COMMUNITY BOARD FEEDBACK PACKAGE

DINING OUT NYC

Business Name: Rice X Beans

Application Number: 20240803010204

Sidewalk Cafe Site Plan Form

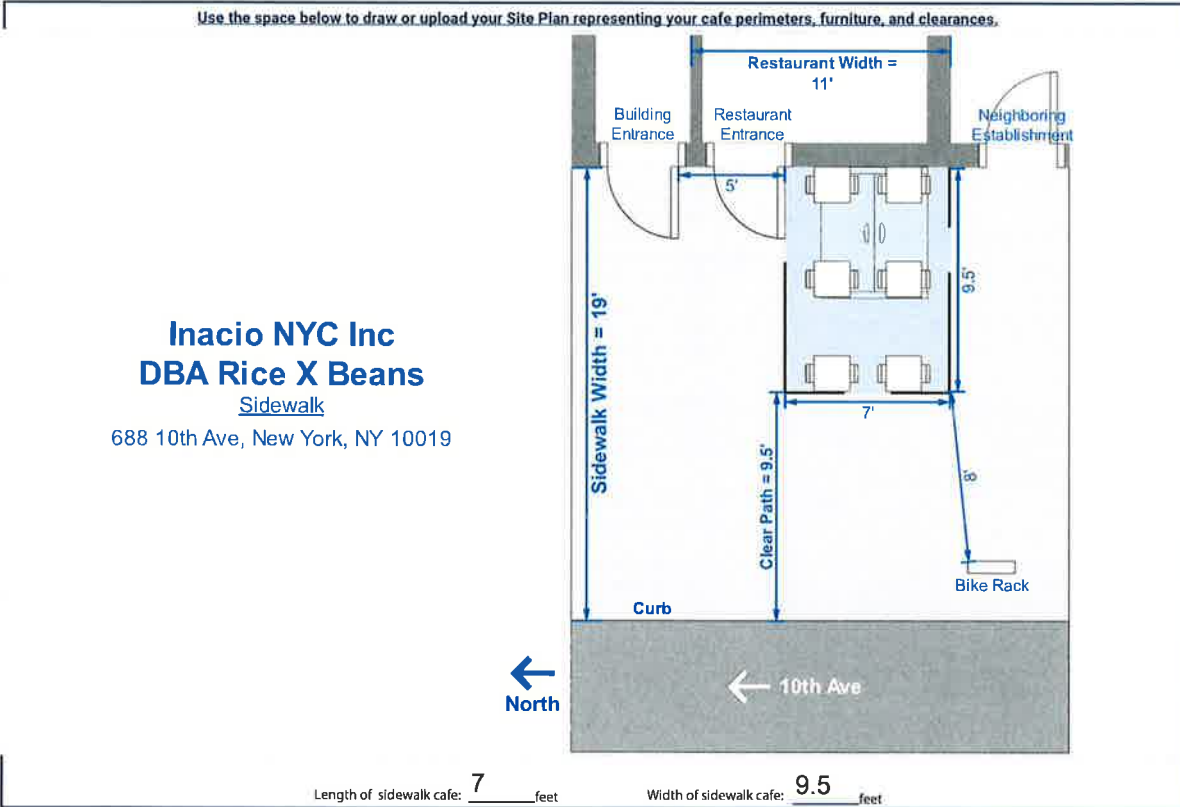
Because this sidewalk is 19 feet wide, the required clear path must be 50% of the width of the sidewalk -- or 9.5 feet. The proposed Site Plan does not provide for the required 9.5 foot clear path at all points: There is only 8 feet between the bike rack obstruction and the perimeter of the sidewalk cafe.

Although MCB4 recommends Approval, MCB4 urges that the site plan be modified to provide for the required 9.5 clear path between the bike rack obstruction and the perimeter of the sidewalk cafe.
